Forensic Building Defects Report

1 Sample St Suburb VIC 3000 (PS 123456X)

31 August 2018

Roscon Property Services were engaged by OC manager to conduct a Forensic Building Defects Report for the property at 1 Sample St Suburb VIC 3000. The investigation was undertaken on Thursday 15 August 2018 at approximately 9:00am.

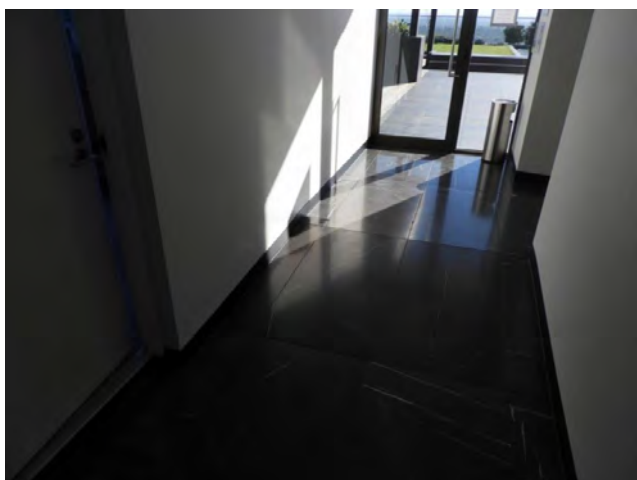
Item	Details	Photographic Details
5.	<p>Location:</p> <p>Level 14 - External hot water plant area</p> <p>Finding:</p> <p>It has been noted that at the time of inspection that water was ponding on the floor due to the lack of appropriate fall towards the floor waste causing water to chronically pond on the rooftop.</p> <p>AS 4654.2-2012 Clause 2.5.2 states:</p> <p><i>Falls in finishes shall ensure water drains to the drainage outlet. Water shall not be retained on the finished surface with the exception of residual water remaining due to surface tension. The fall shall be in the structural substrate, or formed by a screed over the structural substrate.</i></p> <p>NOTE: Falls for surface drainage should be no flatter than 1 in 100.</p> <p>A defect has been noted.</p> <p>Recommendations:</p> <p>The existing waterproofing membrane is to be stripped off the plant area with the concrete substrate being completely exposed.</p> <p>A layer of screed is to be applied to the substrate and is to be graded so that falls at a minimum grade of at least 1 in 100 towards the floor waste can be achieved.</p> <p>A new layer of waterproofing is to be applied to the plant area in accordance with AS4654.2-2012.</p>

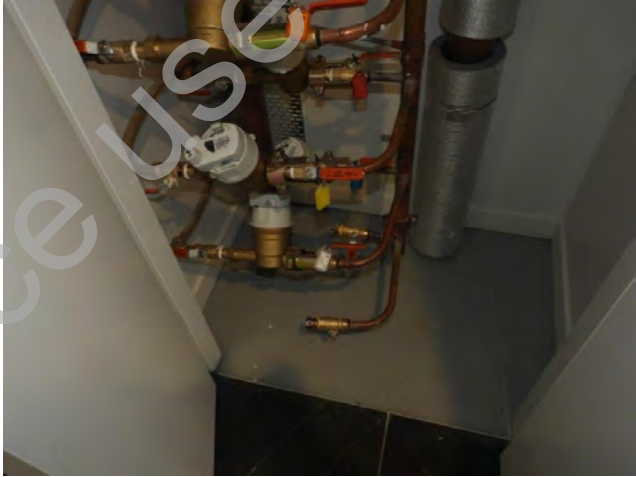
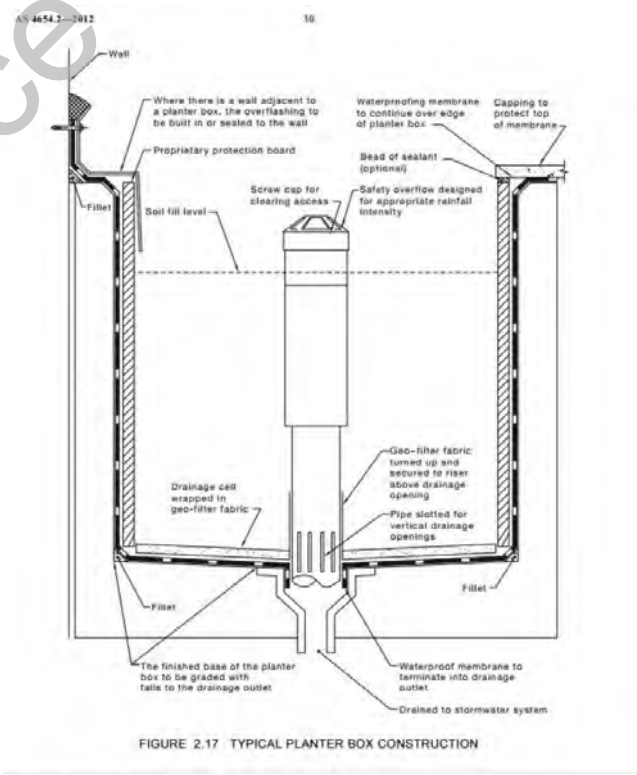
Item	Details	Photographic Details
6.	<p>Location:</p> <p>Planter boxes on level 12 Common area Courtyard</p> <p>Finding:</p> <p>Upon inspection, Roscon staff was only able to dig approximately 50mm into the planter boxes as the rocks made it difficult to go any further. It was noted that the planter boxes along the eastern edge do not contain a water proofing membrane and protection boards. Water will be able to seep out of the planterbox causing damage to the building over an extended period of time.</p> <p>Clause 2.13 of AS4654.2-2012 requires planterboxes to be tanked with a waterproofing membrane that extends 100 mm above the soil level. Protection boards are to be installed in front of the membrane to protect the membrane from plant roots.</p> <p>AS 4654.2-2012 clause 2.13 states:</p> <p><i>"The membrane shall be sealed to the drainage outlet. It shall extend vertically to a height of 100 mm above the soil or fill level. Falls in the base of the planter shall be in accordance with Clause 2.5.2."</i></p> <p>NOTES:</p> <ol style="list-style-type: none"> 1 The planter box should be provided with a suitable overflow. 2 Protection boards should be provided to minimise root damage to the waterproofing membrane. The suitability of the plants to be installed should be considered, as certain rooting systems are aggressive and may penetrate the membrane. 3 Mulch should be considered when determining the soil fill level. 4 Externally exposed walls of planter boxes should be waterproofed to prevent failure of the internal planter box membrane. 5 A typical example of waterproofing inside a planter box is shown in Figure 2.17." <p>Image 3 shows the typical construction of a planter box with a water proofing membrane in accordance to Figure 2.17 from AS 4654.2-2009.</p> <p>A defect has been noted.</p> <p>Recommendations:</p> <p>Ensure that tiled planterboxes contain a waterproofing membrane underneath that is intact.</p> <p>Remove all soil from the planter boxes and store onsite.</p> <p>Clean the substrate of the planter box so that it is ready for a membrane application.</p> <p>Supply and Install a membrane in accordance with AS4654.2-2012 ensure that the membrane extends 100 mm above the soil level, is flashed, has a drainage overflow with protection boards.</p> <p>It is also suggested, that protection boards be put in place to protect the membrane from plant roots.</p>	   <p>FIGURE 2.17 TYPICAL PLANTER BOX CONSTRUCTION</p>

Item	Details	Photographic Details
7.	<p>Location:</p> <p>Glass Doors in Common Area Hallways.</p> <p>Finding:</p> <p>The glass doors throughout the building do not have any decals. These are prominent in areas found throughout car parks to lift access, the lobby, and entrances to courtyards. This is a safety hazard as the glass panes are transparent and pedestrians may collide into the glass, which can lead to serious injury.</p> <p>AS 1428.1-2009, clause 6.6 states:</p> <p><i>"Where there is no chair rail, handrail or transom, all frameless or fully glazed doors, sidelights, including any glazing capable of being mistaken for a doorway or opening, shall be clearly marked for their full width with a solid and non-transparent contrasting line. The contrasting line shall be not less than 75 mm wide and shall extend across the full width of the glazing panel. The lower edge of the contrasting line shall be located between 900 mm and 1000 mm above the plane of the finished floor level. Any contrasting line on the glazing shall provide a minimum of 30% luminance contrast when viewed against the floor surface or surfaces within 2 m of the glazing on the opposite side."</i></p> <p>A defect has been noted.</p> <p>Recommendations:</p> <p>Engage the builder to apply required marking in accordance with Clause 5.19.3 Marking of AS 1288-2006, which states:</p> <p><i>"Marking, where required, shall be in the form of an opaque band not less than 20 mm in height and located so that the vertical distance from the floor level is-</i></p> <p><i>(a) not less than 700 mm from the upper edge of the band; and</i></p> <p><i>(b) not more than 1200 mm to the lower edge of the band.</i></p> <p><i>The band shall be readily apparent. This may be achieved either by ensuring that the band contrasts with the background or by increasing the height of the band."</i></p>

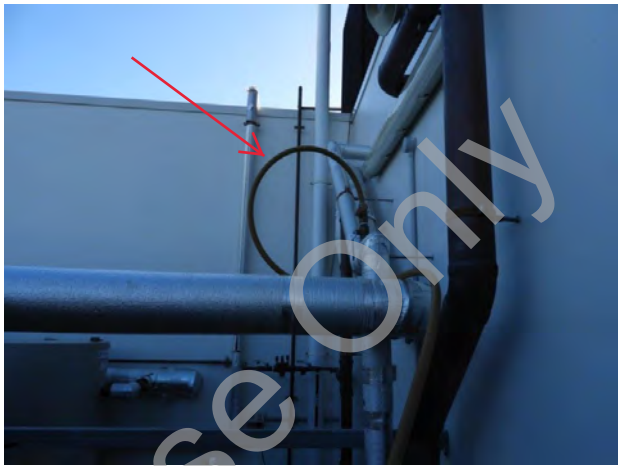
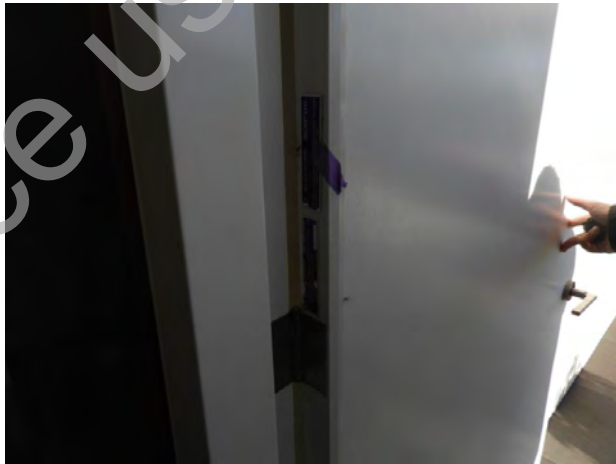
Item	Details	Photographic Details
39.	<p>Location:</p> <p>Level 14 - South-West bulkhead</p> <p>Finding:</p> <p>Paint blistering and cracks on the plasterboard were observed at the South-West bulkhead. These are signs that are consistent with water ingress. At the time of inspection, there was no elevation in moisture recorded, as shown in image 2. From the civil drawing C19 shown in image 3, there is a floor waste that leads to a down pipe directly above the bulkhead. This indicates that waterproofing membrane for from the roof has failed and water ingress has occurred at this point.</p> <p>The NCC 2015 performance requirement FP1.4 states:</p> <p><i>"A roof and external wall (including openings around windows and doors) must prevent the penetration of water that could cause—</i></p> <p><i>(a) unhealthy or dangerous conditions, or loss of amenity for occupants; and</i></p> <p><i>(b) undue dampness or deterioration of building elements."</i></p> <p>A defect has been noted.</p> <p>Recommendations:</p> <p>The builder is to rectify this issue and ensure that the waterproofing membrane on the roof has not been compromised and water is unable to enter the building.</p> <p>The plasterboard of the bulkhead is to be removed and replaced with new plasterboard. Matching white paint is to be supplied and applied onto the entirety of the new bulkhead walls.</p> <p>Refer to Item 3 in the Major Defects section for recommendations on how to rectify the waterproofing membrane on the roof.</p>

Carpark - Stage 1

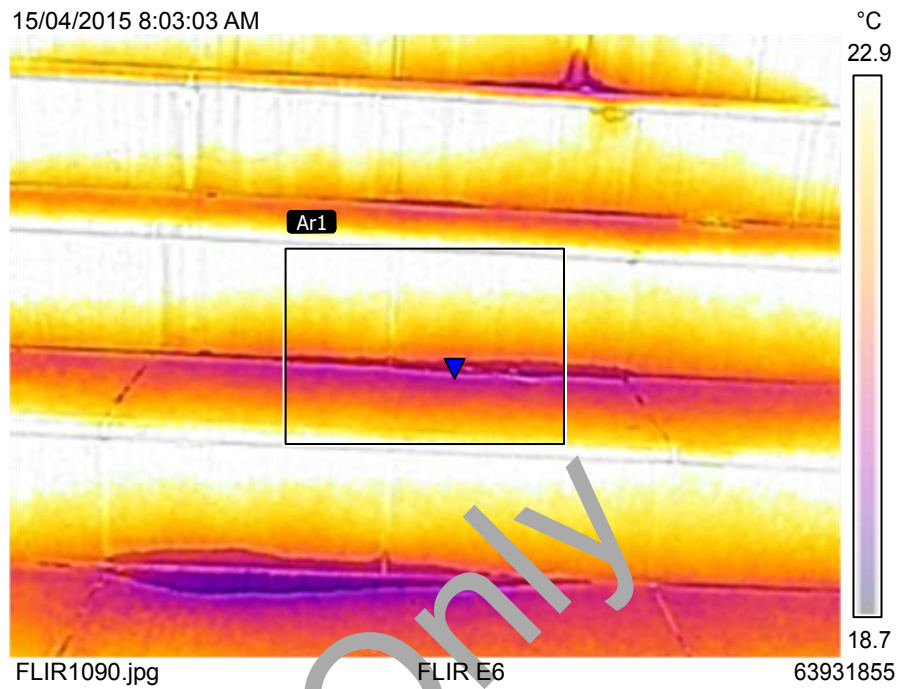
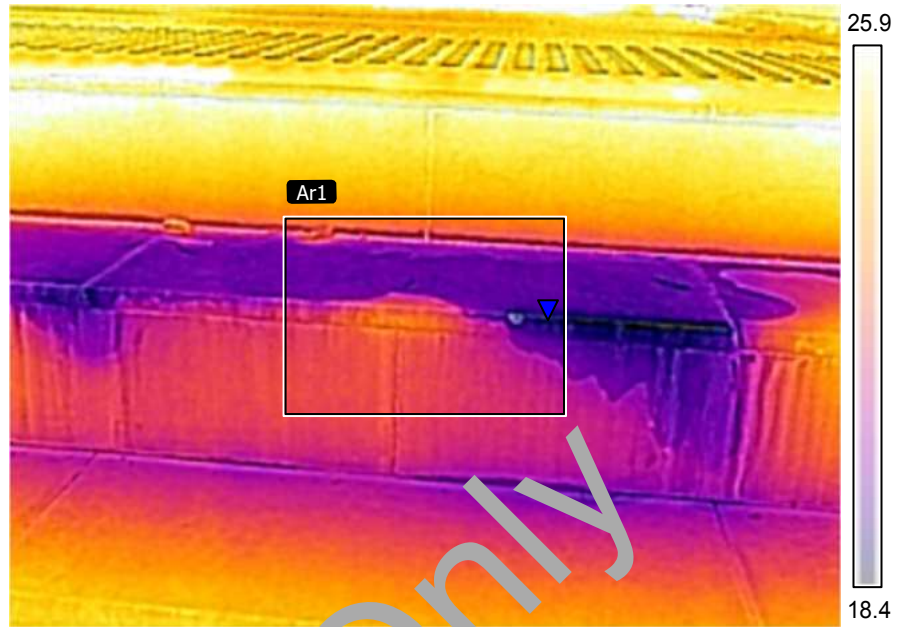
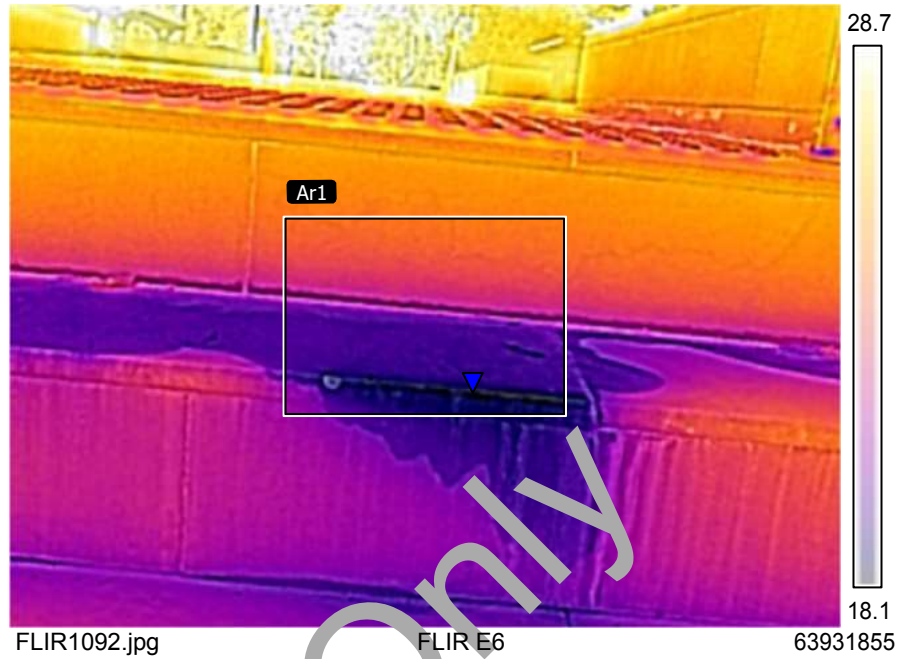
Moisture can be seen penetrating the blockwork wall and causing efflorescence to be seen on the surface of the blockwork wall. On the other side of this blockwork wall there is a garden bed which may be contributing to the water ingress if it is not correctly water proofed.

1093, 1094 and 1095

Carpark - Stage 1

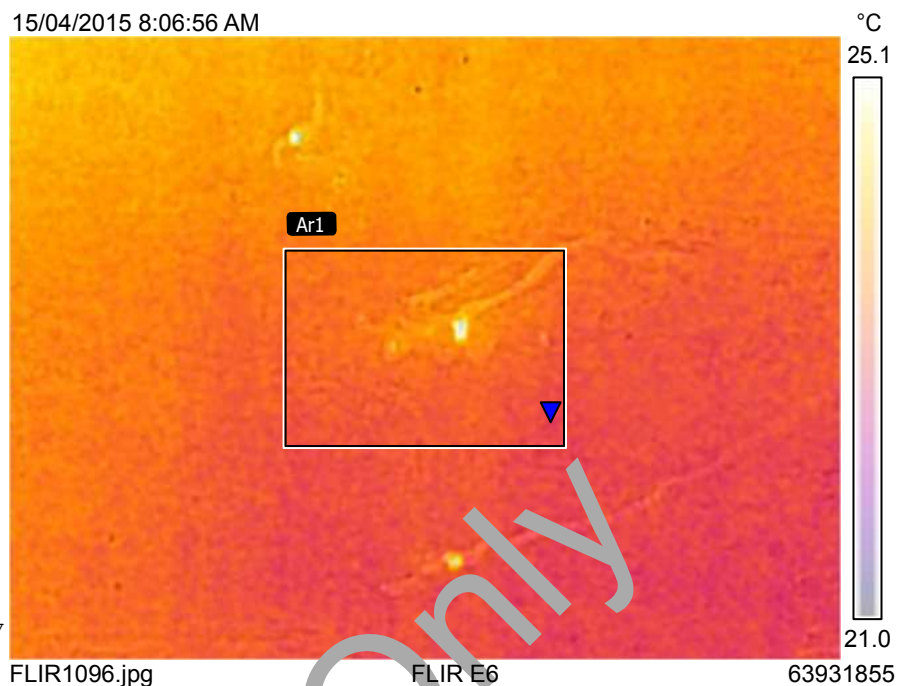
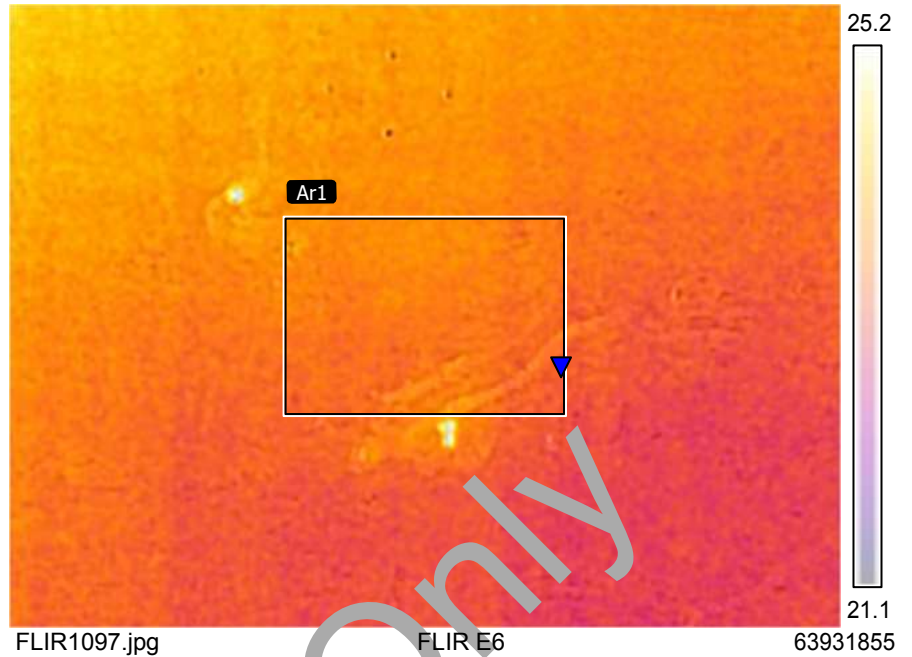
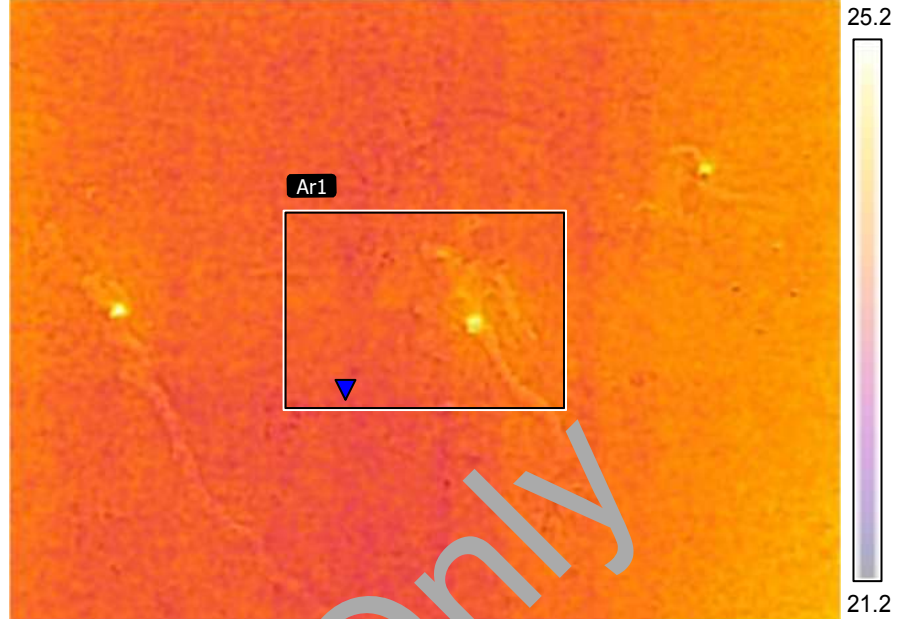
Stalactites can be seen forming on the soffit of the concrete slab. This is the result of a continuous water leak coming from the apartment above.

Investigative works are to be carried out by a licensed plumber to determine the origin of the water leak and to rectify it to ensure no further water penetrates the slab.

Prolonged exposure to water can result in the slab losing its structural integrity over a long period of time.

This is evident in photos: 1096, 1097 & 1098
